BULLETIN NO: MK20A-06 Rev A

APPLICABLE TO: MK20A ILS (including MK20A LOCALIZER and MK20A GLIDE SLOPE) and MK20C MARKER BEACON

SUBJECT: Thales has identified an issue wherein mismatched DC-DC converters (Part No. 120293-0001) located in a MK20A system can exhibit a high voltage output and lead to a system reset when the system is a dual configuration.

120293-0001 DC-DC Converter

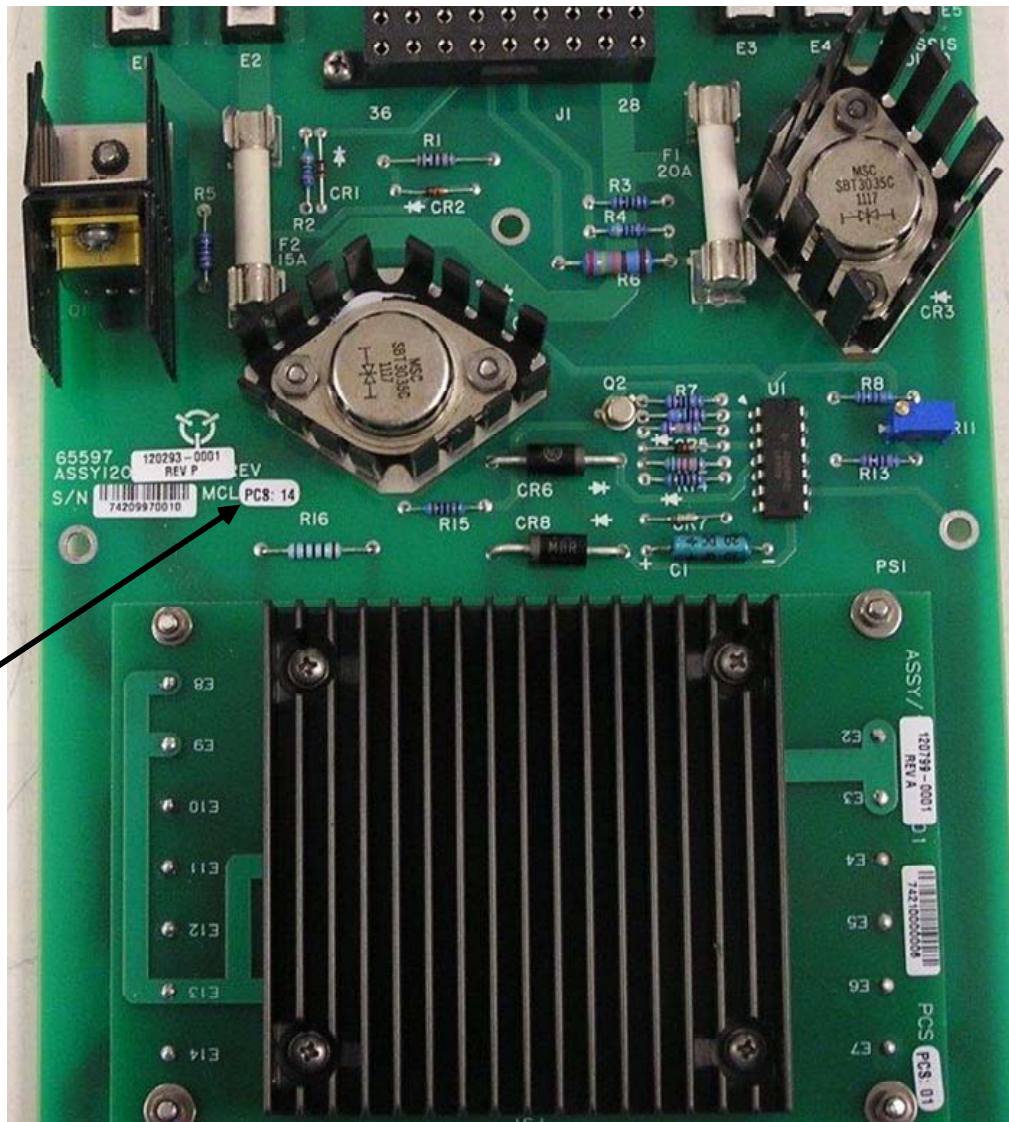
The 5.0 VDC output of the DC-DC converter (Part No. 120293-0001) PCS version 14 or 15 may be operating at an output level near 5.2 VDC. This output level is higher than previous versions of DC-DC converters (PCS versions 13 or lower), which operates at a nominal 5.0 VDC. The higher output level can cause mismatched voltages between two different DC-DC converters if both versions are installed in a MK20A system, impacting the MK20A system's availability and reliability. The MK20A will issue a system reset if a DC-DC converter failure/off condition occurs in a dual system, and this reset will cause the dual system to temporarily lose all communications and take both transmitters off-line for the reset time interval.

To determine whether your DC-DC converter (Part No. 120293-0001) located in your MK20A system and/or system spares should be returned to Thales, please check the PCS version number located on your DC-DC converter or converters. For your reference, Thales has included a picture of the DC-DC converter below that delineates the location of the PCS version number. If you have a DC-DC converter that has a PCS version number that is 14 or 15, please contact Thales Customer Service at the phone number or e-mail listed below to make arrangements to immediately return the DC-DC converter to Thales for repair or replacement at Thales' cost. **Please note that DC-DC converters (Part No. 120293-0001) with PCS version 13 or lower and DC-DC converters (Part No. 120293-0001) with PCS version 16 or higher are NOT subject to this recall.**

Thales has designed and tested a modification to the DC-DC converter (Part No. 120293-0001) that will resolve the output issue and stabilize the voltage at 5.0 VDC. Thales is requesting that all DC-DC converters (Part No. 120293-0001) that are marked with PCS version 14 or 15 be immediately returned to Thales for repair or replacement at Thales' cost.
